CCU SLURRY PRODUCT PUMPS
P-9693 LOOSE IMPELLER NUT

On Monday, December 9, 1985, the slurry product pump, P-9693 was pulled out due to electric driver overloading and shutting down.

EXAMPLE

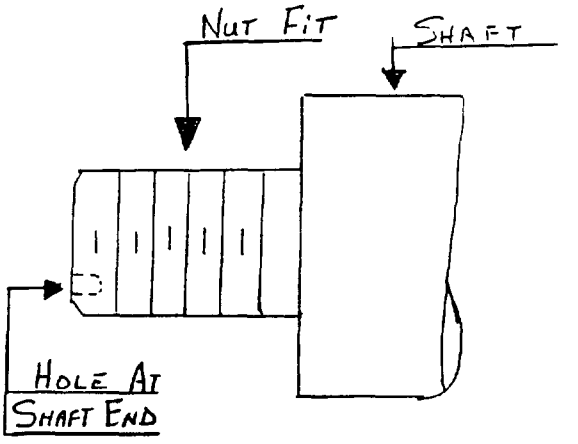
2. Follow the Lawrence Pump recommendation no. 2 (A). (See Page 1)

(i.e. drill thru set screw hole into shaft end approx. 1/8" deep. Use long enough set screw to "stake".)

REAR VIEW OF LINER

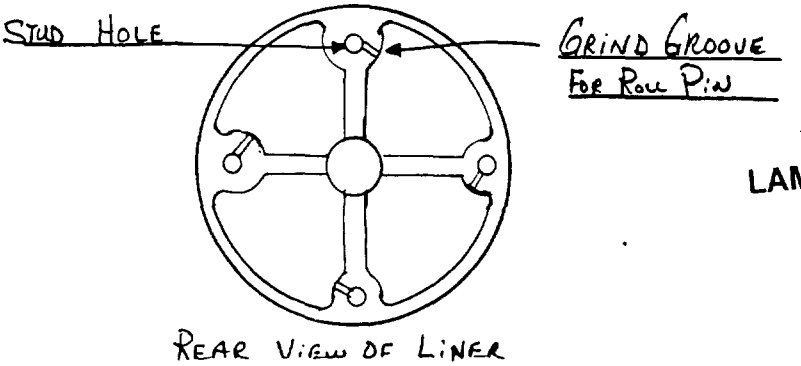
3. **LOOSE LINER STUDS AND NUTS**
   (Do the following on case and head liners.)

a) Grind a straight round hole perpendicular to the stud hole in liner. Select a gound hole size to that of an available roll pin.
   (See drawing below)

b) Install studs. drill roll pin size hole in stud at previously grind hole in liner.

c) Install roll pin. DO NOT ALLOW ROLL PIN TO INTERFERE WITH PROPER LINER INSTALLATION.
